DEVIATION REQUEST AND DECISION FORM

Project Name :	Eagle Forest Subdivision
Schedule No.(s) :	5208000071
Legal Description :	TRACT IN W2SE4 SEC 8-12-65 AS FOLS, BEG AT PT ON N-S C/L OF SEC 8 WHICH IS 30 FT N OF S4 COR THEREOF, TH NLY ALG SD C/L 1953.29 FT, ANG R 89<09'23" ELY 1299.85 FT, ANG R 90<43'17" SLY 1247.98 FT, TH S 89<22'33" W 622.03 FT, N 39<59'42" W 60.0 FT, S 50<00'18" W 132.81 FT, TH ALG ARC OF CUR TO L HAVING A RAD OF 330.0 FT A C/A OF 50>00'00" AN ARC LENGTH OF 287.98 FT, S 00<00'18" W 422.97 FT, TO PT 30.0 FT N OF S LN OF SEC 8, TH ANG R 89<22'15" WLY PARA TO S LN OF SD SEC 422.17 FT TO POB

Deviation #2: A deviation from the standards of or in Sections **2.3.3.F.3** of the Engineering Criteria Manual (ECM) is requested. The minimum tangent length between broken back curves on a Rural Local street is 200 feet. The deviation request is to allow a tangent length of 140 feet on the north section of Eagle Forest Drive just east of the proposed cul-de-sac. Please refer to the attached Deviation Exhibit.

Deviation Exhibit 2
Broken Back Curve

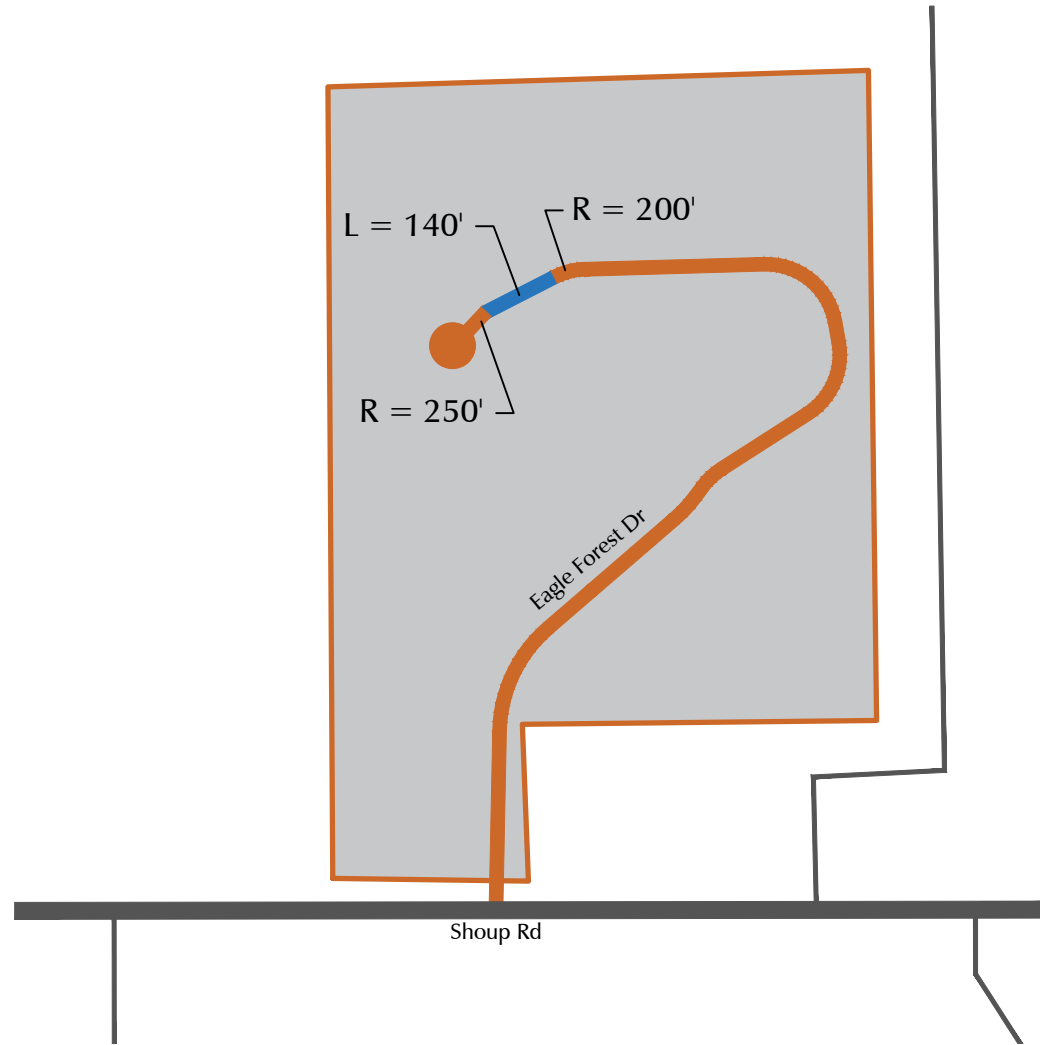
The ECM standard for minimum tangent length between broken back curves on a Rural Local street is 200 feet. The deviation request is to allow a tangent length of 140 feet on the north section of Eagle Forest Drive just east of the proposed cul-de-sac. Therefore, the tangent length would be 60 feet short of the ECM standard.

The aforementioned constraints, combined with the shape of the parcel and the lot sizes needed significantly limits the options for street horizontal alignment. A 200-foot minimum tangent length is not achievable along the northernmost parcels within the site, however the proposed tangent length of 140 feet is achievable.
